I-405 Improvement Project
Amendment 1 - Noise Study Report

Seal Beach Tennis Court Center

In Orange County from SR-73 to the I-605 Interchange

**I-405 WIDENING PA/ED PROJECT
 NOISE RECEIVER &
 BARRIER LOCATIONS ALT1**

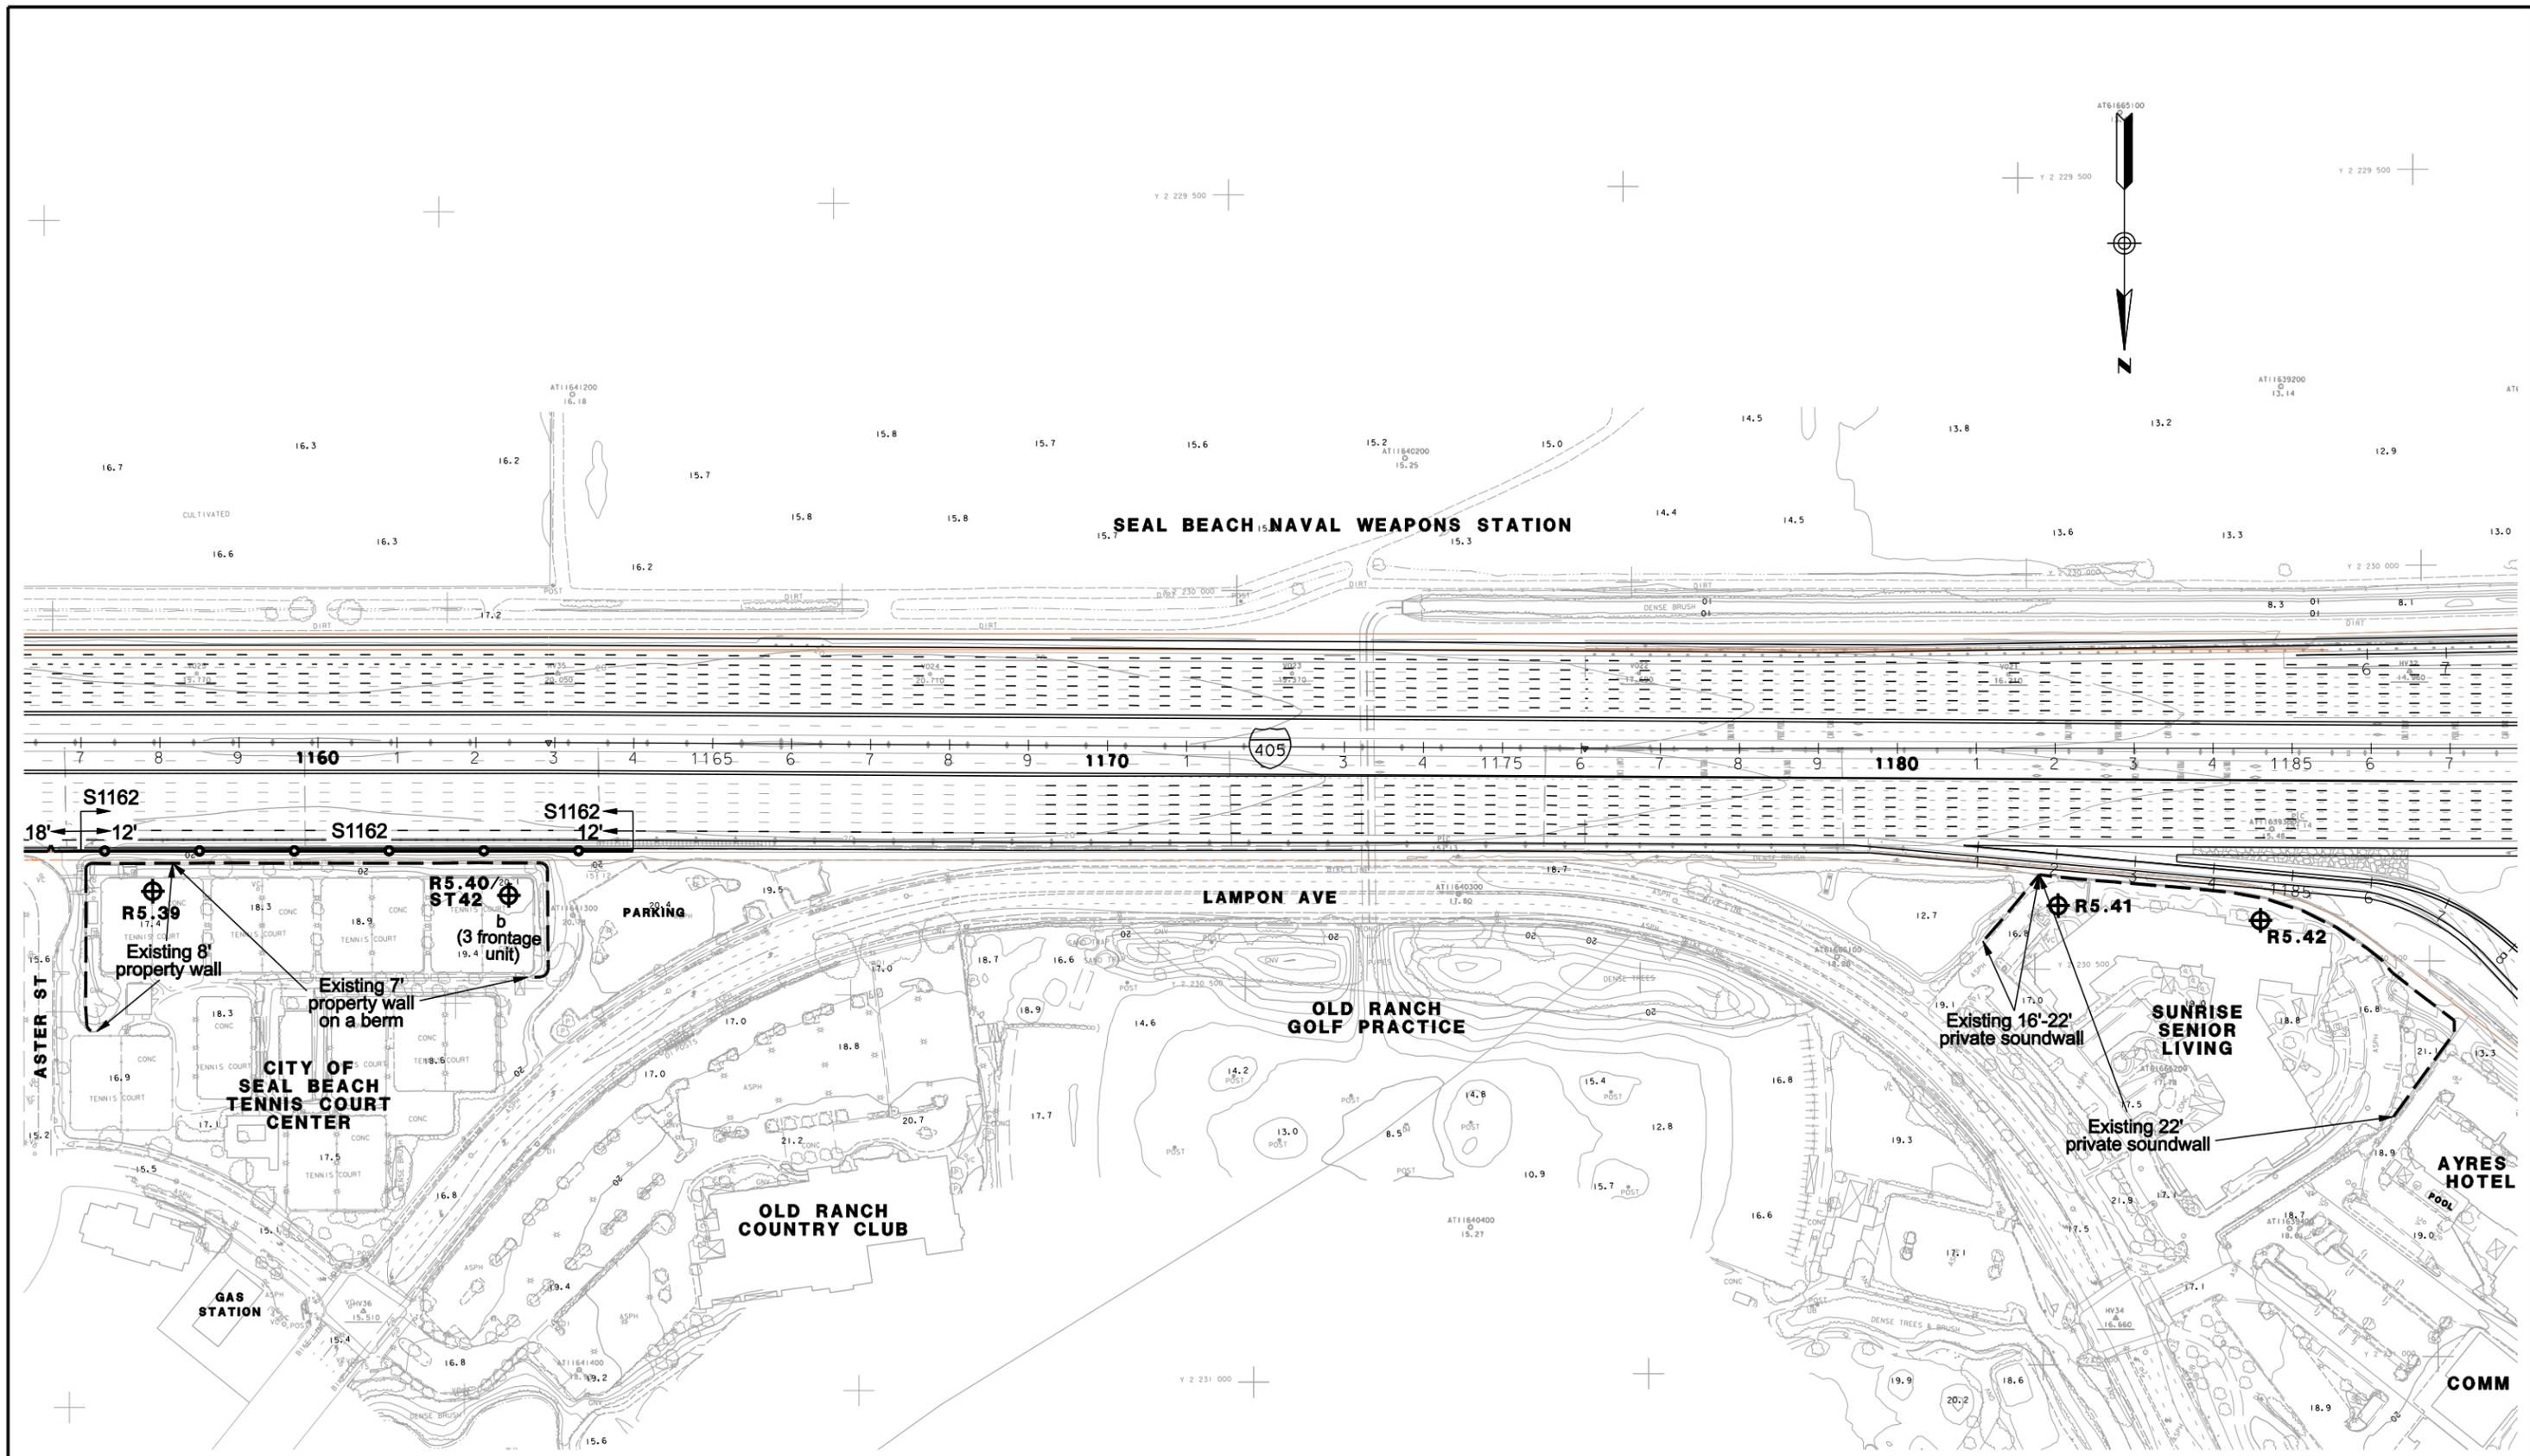
The final Noise Study Report dated June 2011 conducted for I-405 Improvement Project had identified Soundwall S1162 adjacent to the City of Seal Beach Tennis Court Center, as a feasible abatement measure for Alternatives 1, 2, and 3. However, NADR had concluded that this soundwall cannot be constructed within determined allowance for any build alternatives; therefore, it had concluded that this soundwall will not be considered reasonable for Alternatives 1,2, and 3. Upon further review it was determined that because the length of tennis court area along I-405 is approximately 550 feet, a higher number of benefited units –equivalent to benefited residence- can be considered for the noise analysis. As every 100 feet of exposed area is considered one frontage unit, six frontage units should have been considered in for the noise analysis instead of two.

The following are revised tables for each alternative that show the corrected frontage units and attached are corrected figures. It was assumed that Receivers R5.39 and R5.40 each represent three frontage units. NADR will also be revised to consider this correction.
